IN THE DRAWINGS:

REMARKS

FIG. 4

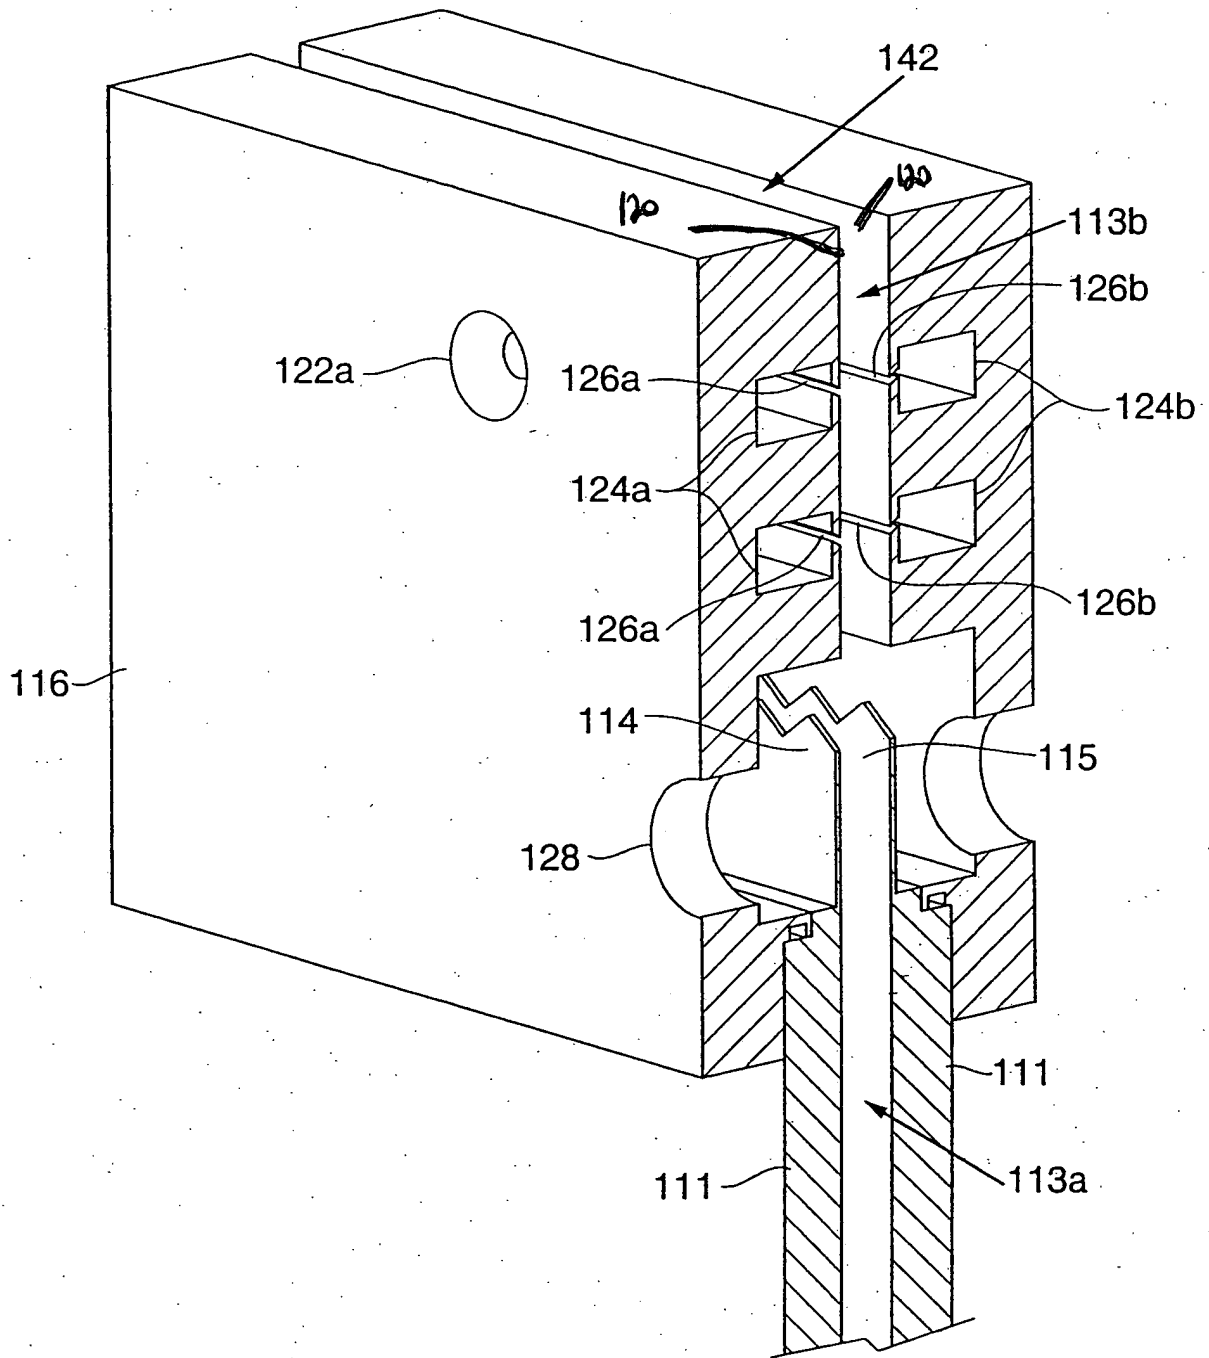
The attached sheet of drawings includes changes to Figures. 4 and 7A. These sheets, which include Figures 4 and 7A, replaces the original sheets including Figures 4 and 7A. In Figure 4, previously omitted element 120 has been added. In Figure 7A, previously omitted element 106a has been added.

The specification has been amended to correct minor editorial problems. In amended Figure 4, the previously omitted element numeral 120 has been added. In amended Figure 7A, previously omitted element numeral 106a has been added. The reference to end effector 106 on page 24, line 4 has been corrected to refer to Figure 6. The reference to "containment vessel" has been changed to "fluid handling system" on page 6 at line 9. Element numeral 122b on page 24, line 14 now refers to Figure 5. Reference numeral 102a has been deleted on page 25 at line 28. Element Z has been amended to reference Figures 2A-2C on page 30 at line 28. The reference to "lower opening 135 (Fig. 3B)" has been changed to "lower opening 135" on page 24, line 11.
